**Santa Margarita River  
Flood Control Project  
MILCON Project P-010**

**Basilone Road Bridge  
Replacement  
MILCON Project P-030**

**FINAL  
ENVIRONMENTAL IMPACT STATEMENT**

### FINAL ENVIRONMENTAL IMPACT STATEMENT SANTA MARGARITA RIVER FLOOD CONTROL PROJECT (P-010), BASILONE ROAD BRIDGE REPLACEMENT PROJECT (P-030), AND CLEAN WATER ACT 404(b)(1) EVALUATION CAMP PENDLETON, CALIFORNIA

Figure 4.2-1

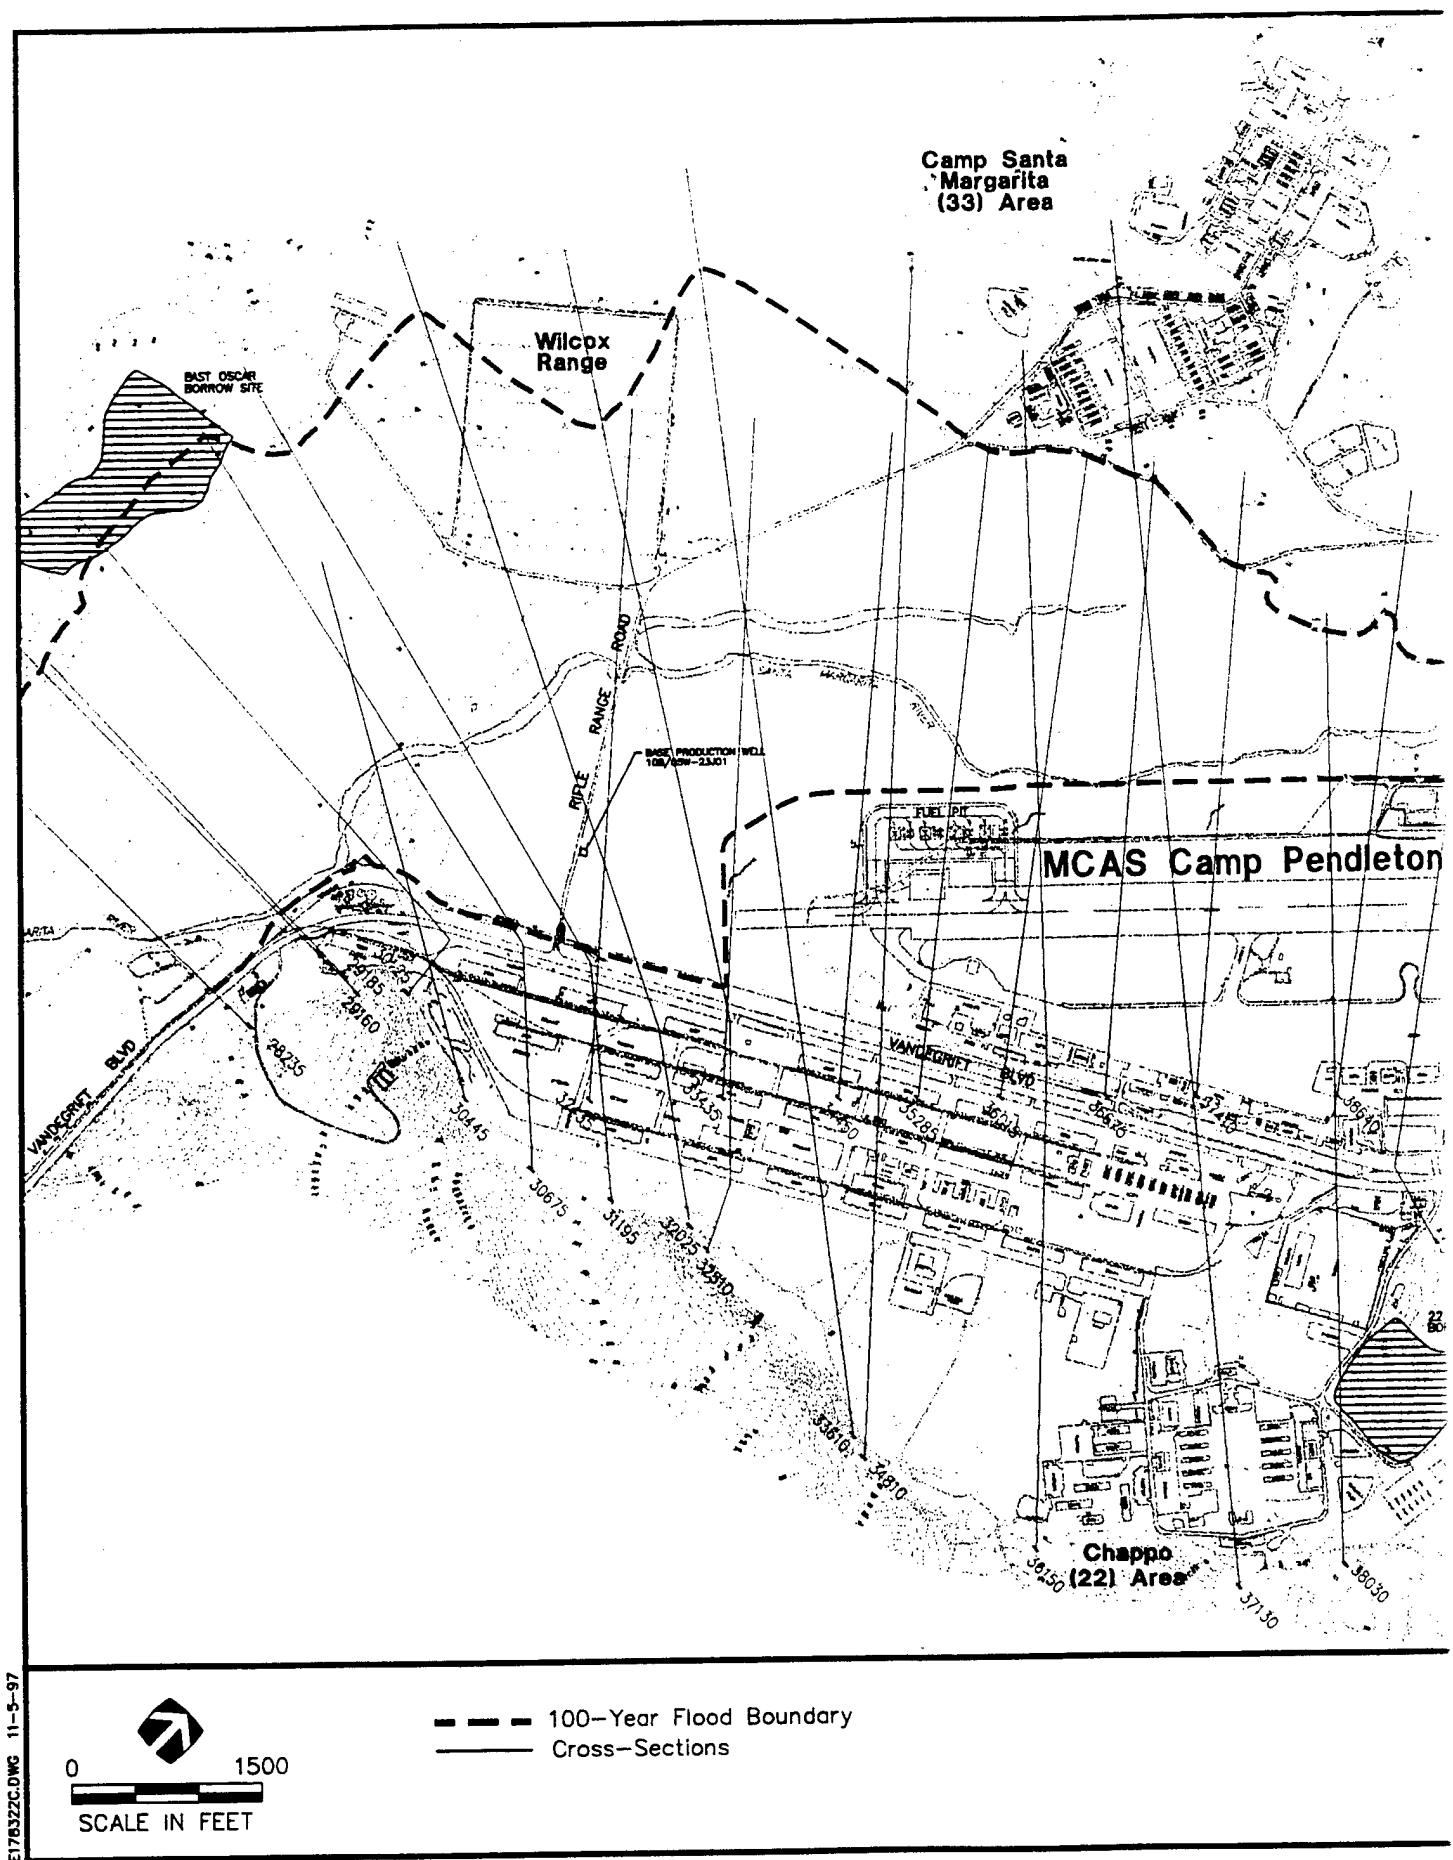
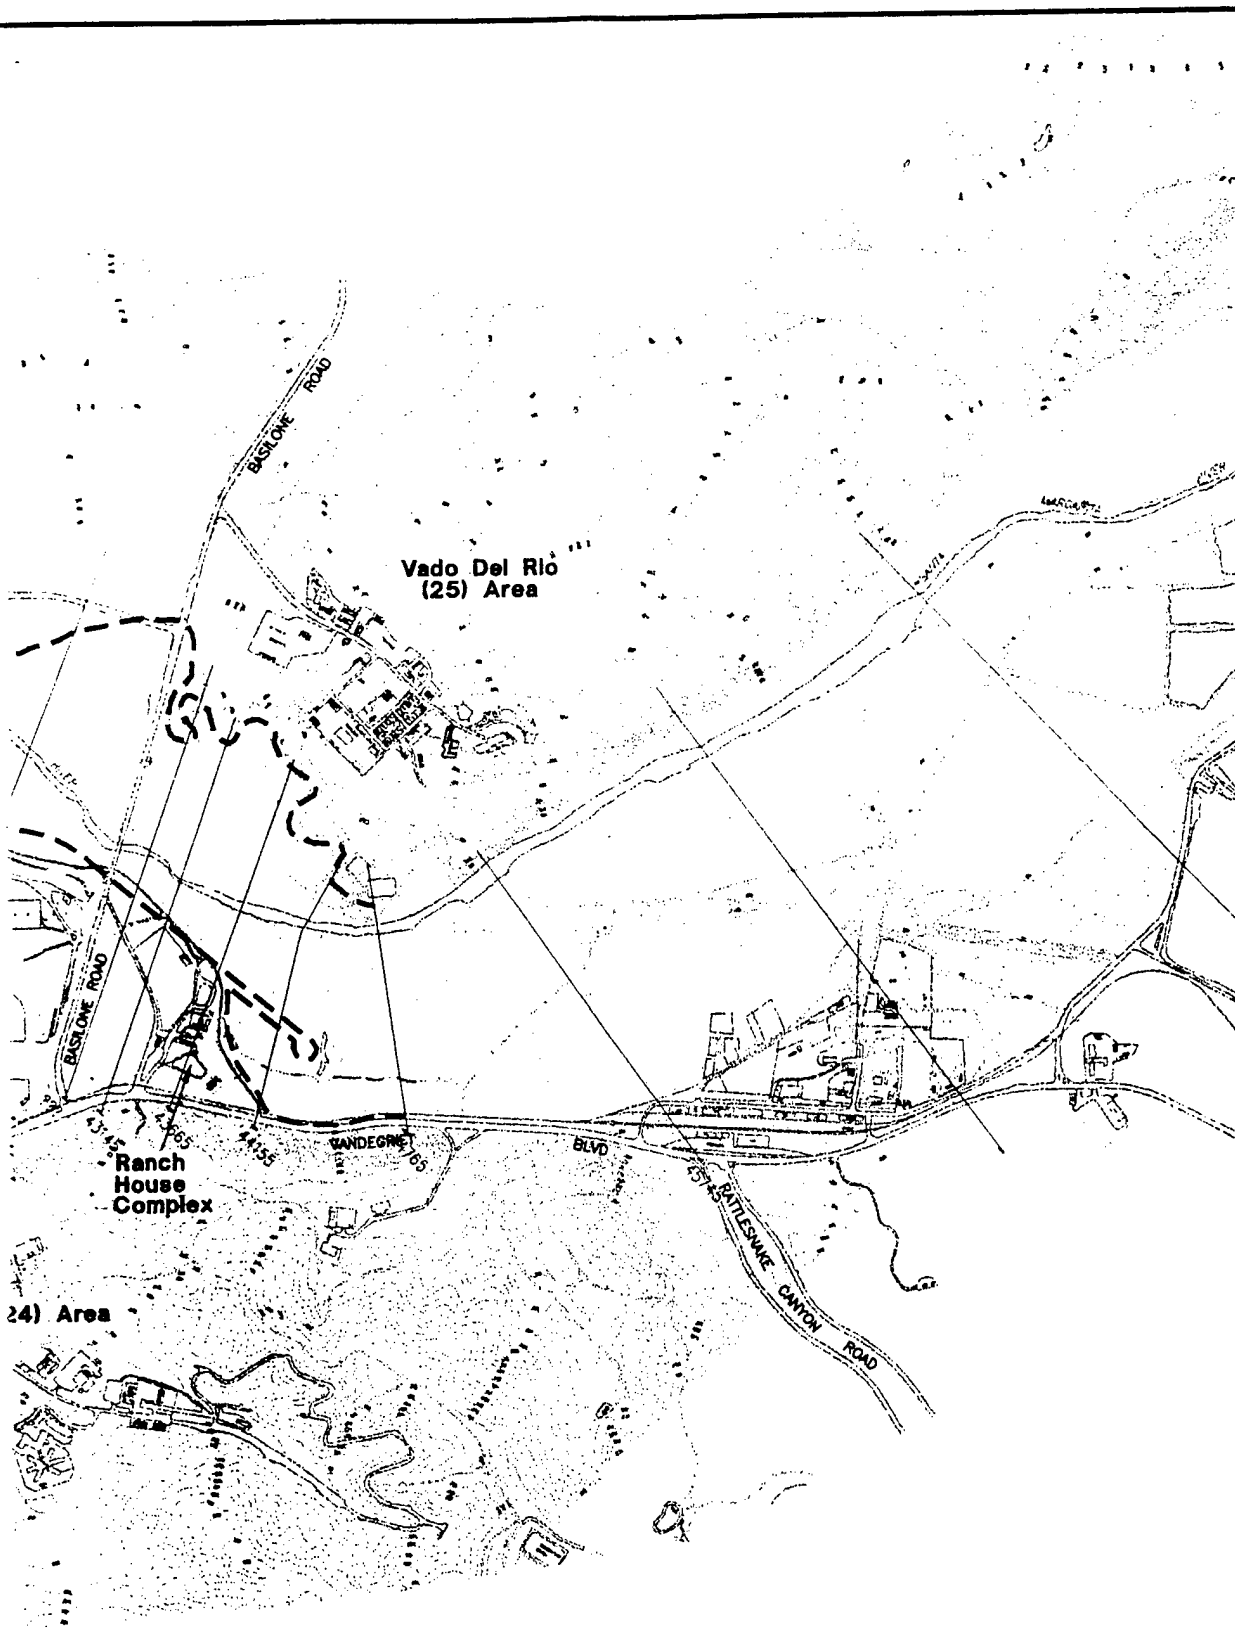
6.17	4	4.2-5	4.1.2.1	4. Page 4.2-5. Under Stormwater Management System it is not clear as to the location of the temporary inundation area "behind" the Chappo (22) area. This should be shown on Figure 4.2-1.	Comment noted. The inundation area is within the Chappo (22) area. Figure 1.2.2 has been edited to show the inundation area. This inundation area is an existing collection basin.
